RE: Macadoodles, PL2022216, Modification Request – Parking Lot

PRELIMINARY DEVELOPMENT PLAN
MACDOODLES 1499 SW MARKET STREET

SITE PLAN

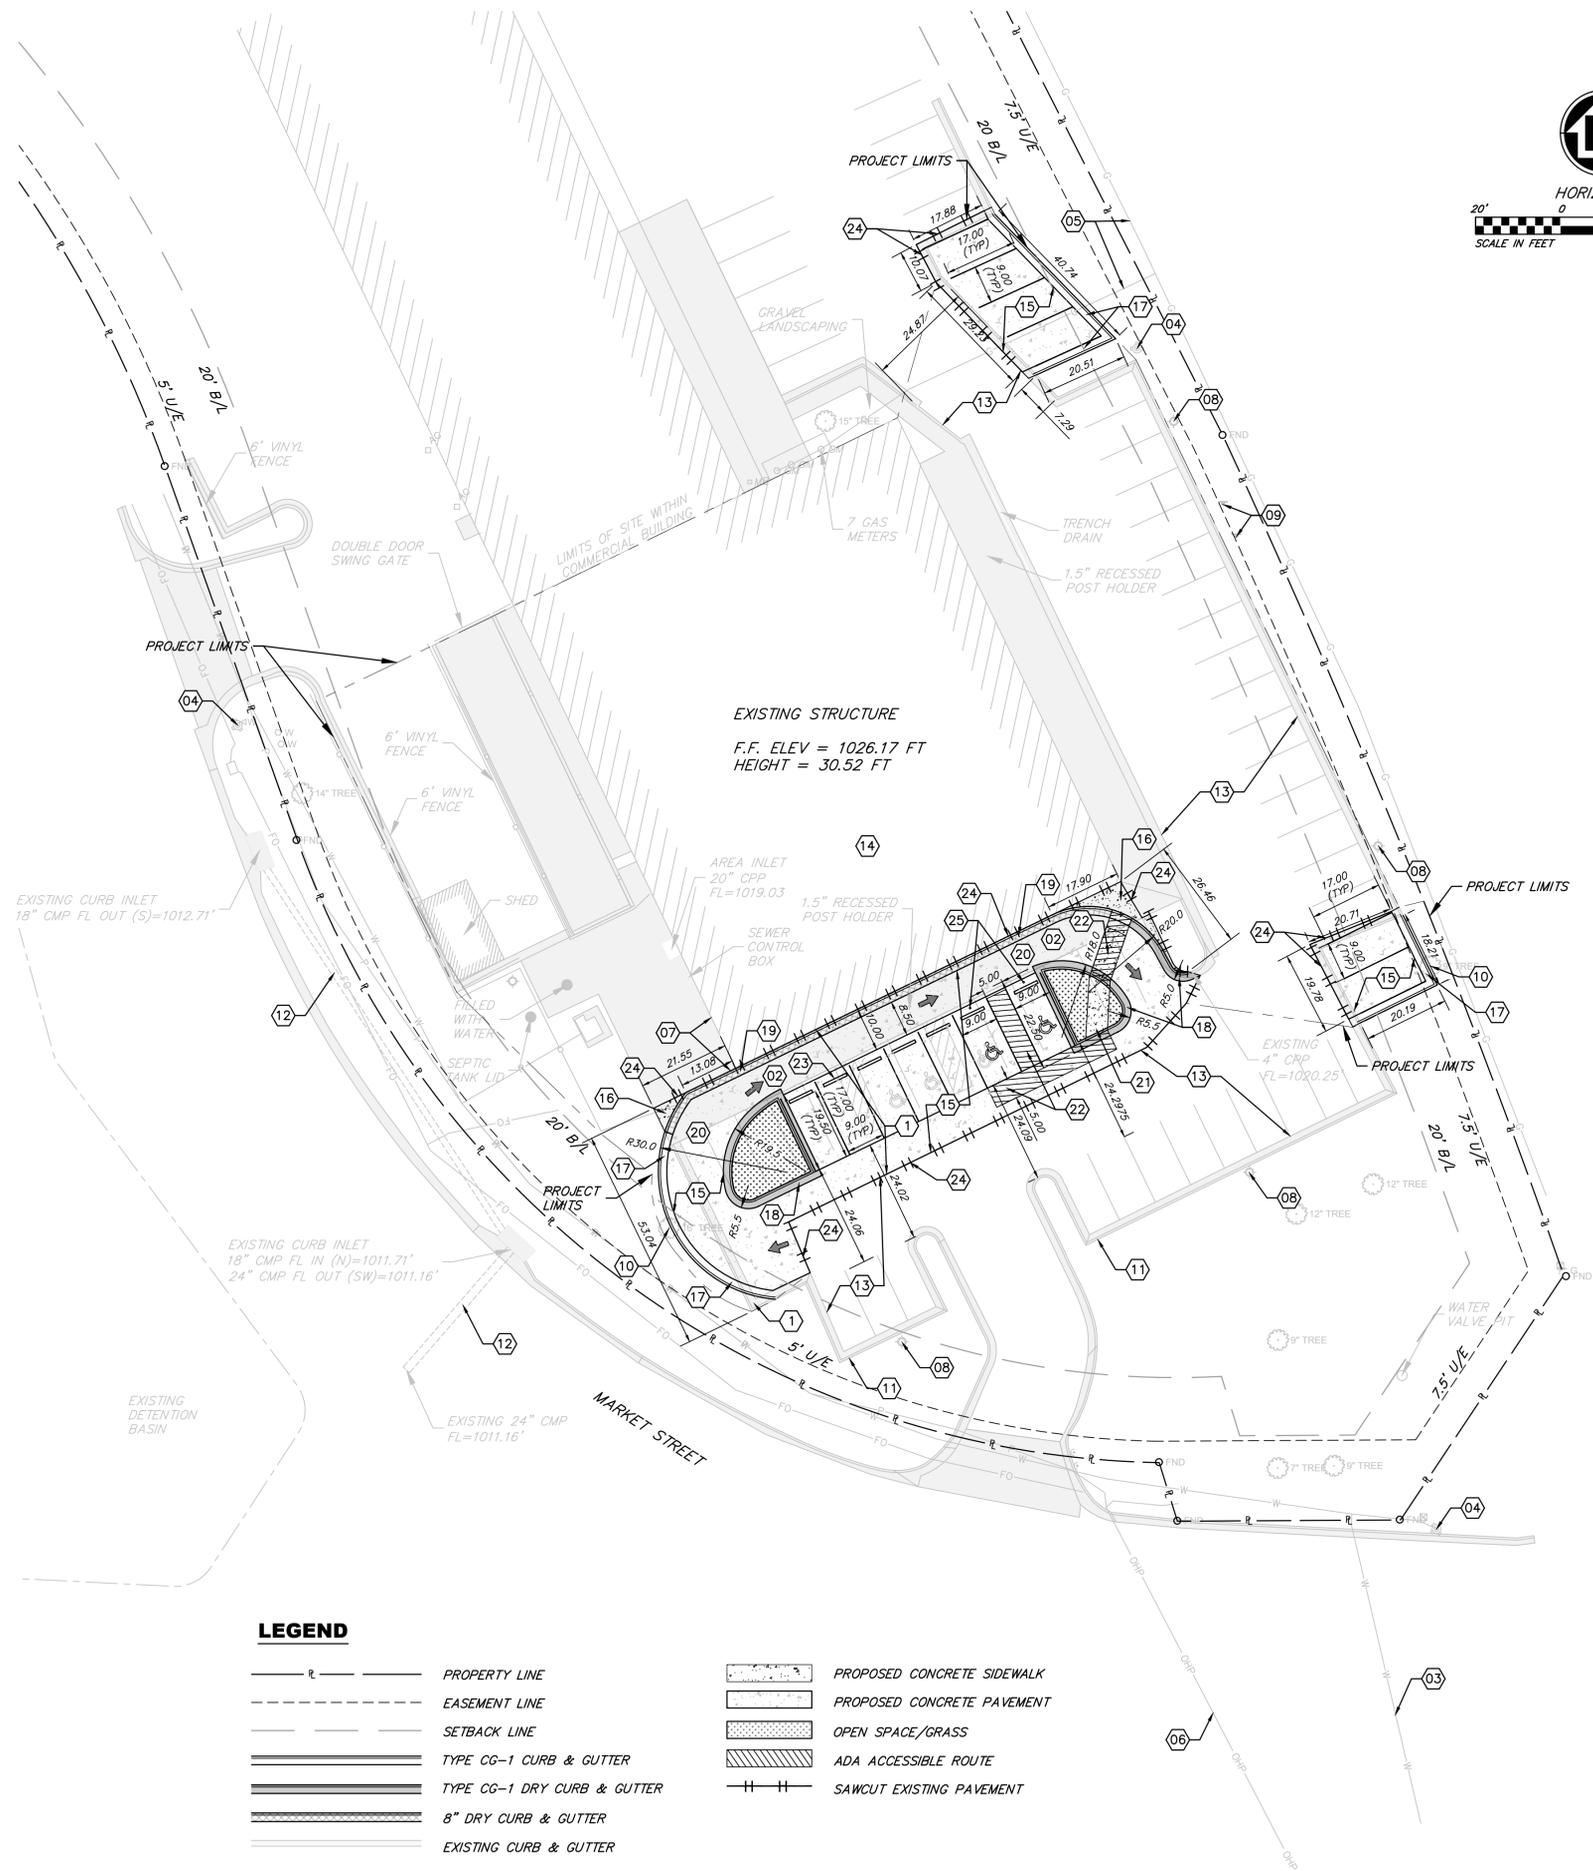
This memorandum supports a parking lot modification request for Macadoodles located at 1499 SW Market Street in Lee's Summit, MO. The modification request is in regards to City of Lee's Summit UDO Article 8.620.E, Parking Lot Design, and Table 8-4 regarding a 24-ft wide access aisle dimensions for 90-degree parking. It has been indicated that this measurement shall be taken excluding curb and gutter.

For the proposed condition, the drive aisle measures just over 24-ft from the proposed parking stalls to the existing face of curb for the two existing entrance island areas. The aisle width meets the 24' in all other locations. It is requested to use the existing commercial building parking lot curb to allow for the measurement of the aisle width as this will be a drivable surface. If not allowed this will create a hardship as the project will grow in scale, as the entire southern portion of the parking lot would need to be reconstructed to be pushed out approximately 1.5-ft. Please refer to Exhibit 1 – Site Plan, attached, for parking lot dimensions.

In conclusion, this parking lot modification requests that the legacy of the existing parking lot allows the 24-wide access aisle dimension to be taken from the proposed parking lot stalls to the existing face of curb, rather than excluding curb and gutter from the dimension.
